Re: Champion Bus  
Defect and Non-Compliance Report

**Subject:** NHTSA Threshold Warning Signal Recall (Recall Number 06E-094)

# Service Bulletin 34273

Instructions for Braun Corporation "Public and Private Use" Dual Parallel Arm Lift Threshold Sensitivity Evaluation and NHTSA Compliance Applicable for NL, NCL and NVL Series Lifts

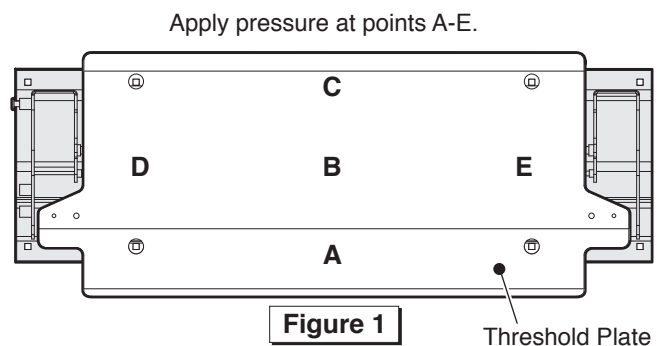
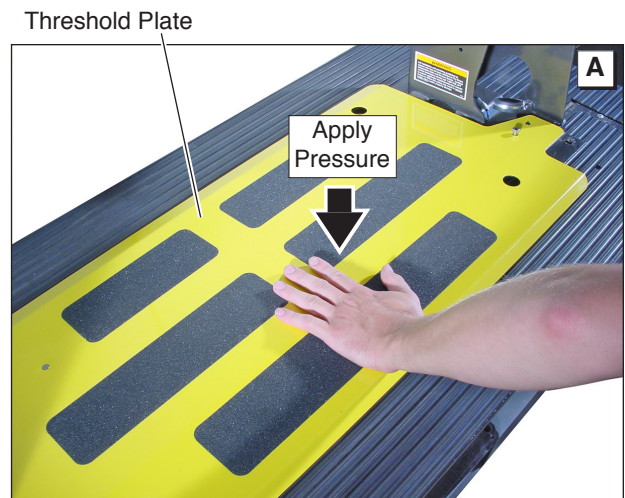
1. Turn Lift Power switch ON. Deploy the lift platform fully to the ground.
2. Apply hand pressure on the center of the threshold plate as shown in Photo A. The visual and/or audible threshold warning\* should be activated when you push down.

Repeat the sensitivity test procedure at positions A-E shown in Figure 1.

3. If the threshold alarm is activated at all positions, no further procedures are required. The lift threshold sensitivity meets NHTSA FMVSS 403/404 requirements.

If the threshold alarm is not activated at all positions, perform the retrofit procedures detailed on pages 2 and 3 of this bulletin. Repeat the sensitivity test procedures following the retrofit. If the lift still does not meet the requirement, contact a Braun Corporation Product Support representatives at 1-800-THE LIFT®.

## Threshold Sensitivity Retrofit Instructions

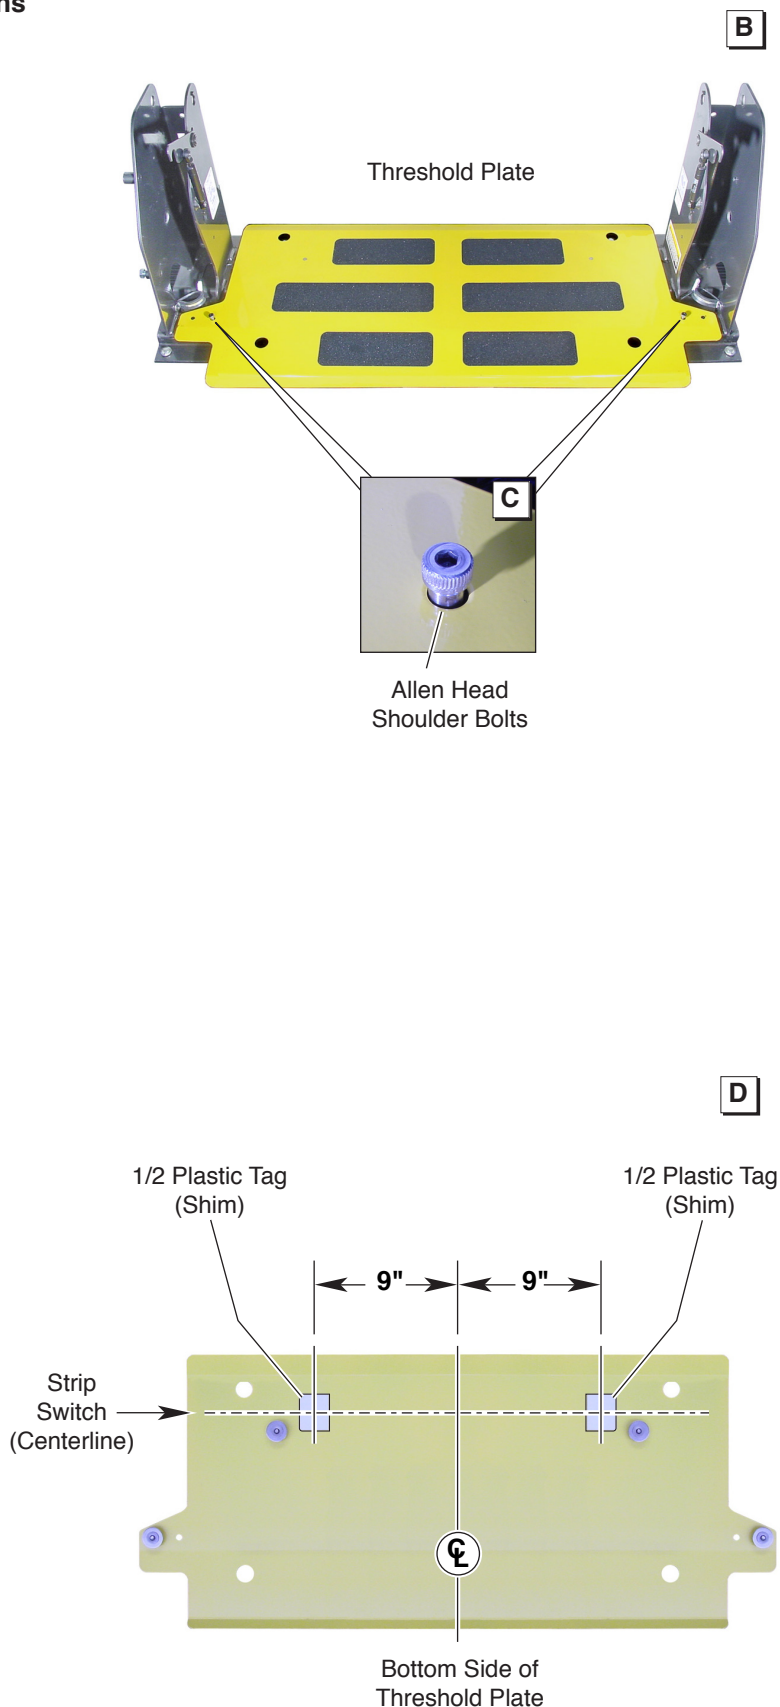
1. Turn Lift Power switch ON. Deploy the lift platform fully to the ground.
2. Remove the threshold plate. Loosen and remove two Allen head shoulder bolts securing the plate (see Photos B and C). Keep bolts. Slide the plate outward and lift to remove it (four keeper standoffs engage key-hole slots). See Photos E, F and G.
3. An adhesive-backed plastic tag is supplied to serve as an alarm activation shim (minimal thickness required to activate the highly sensitive alarm strip switches). Cut the plastic tag in two halves. The plastic tags (shims) will be affixed to the bottom side of the threshold plate (positioned as shown and detailed below).

Turn threshold plate over. See Photo D. The strip switches typically leave an impression (mark) on the yellow plate from use. Use the impression of the inboard strip switch as a centerline for shim positioning (or measure to establish position).

Position each shim 9" from the center of the threshold plate (see Photo D). Align the tags with the strip switch centerline. Clean the surface as detailed below and affix the adhesive-backed tag to the plate (**press firmly**).

**Note:** Clean the surface with isopropyl alcohol before affixing the tag. Use a clean cloth or paper towels. Do not use oily shop rags. Wipe surface free of residue with dry portion of cleaning cloth.

Keeper Standoffs  
(Engagement Studs)

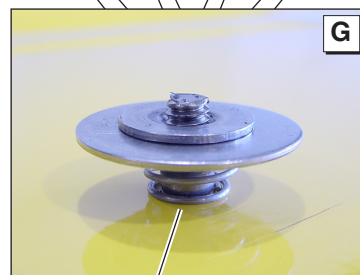
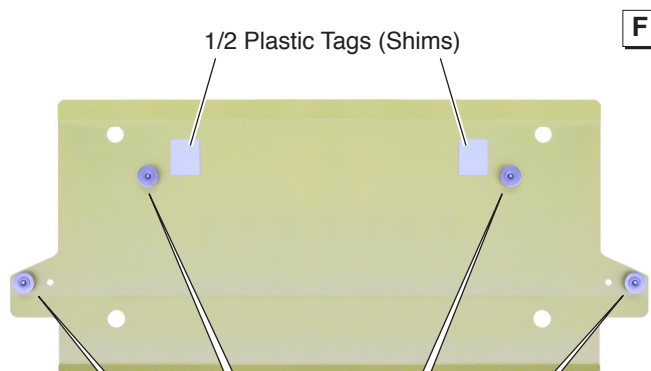
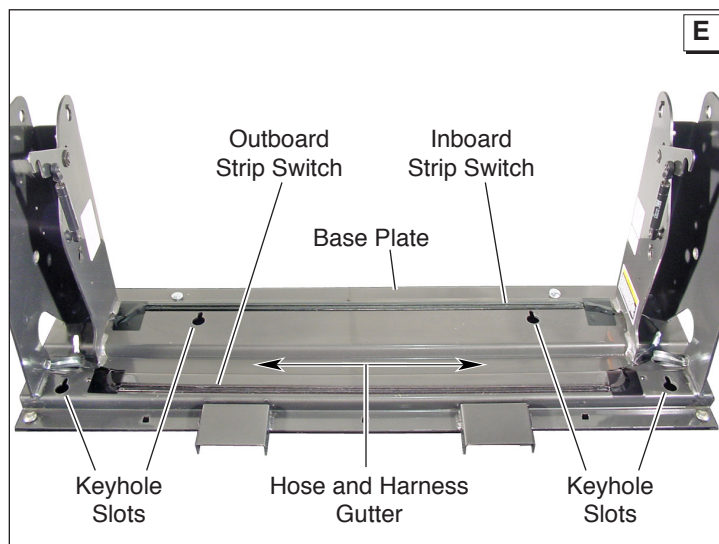
4. Reposition the threshold plate (with shim). Align the keeper standoffs (studs) on the bottom of the threshold plate with the base plate keyhole slots. See Photos E, F and G. Insert studs and **carefully** slide the plate inward (engage slots fully).

**Ensure** all hoses and wiring harnesses routed through the base plate gutter are positioned fully in the gutter and not located anywhere they could potentially interfere with activation of the tape switches. See Photo E.

**Note:** Spraying a light mist of glass cleaner (or other) to the strip switches will aid in the plate sliding easier into position. See Photos E, F and G.

**Ensure** all four keeper standoffs engage the base plate keyhole slots.

5. Reinstall the two Allen head shoulder bolts previously securing the plate (see Photo B and C). Tighten bolts securely.
6. Repeat the sensitivity test procedures outlined on page 1.
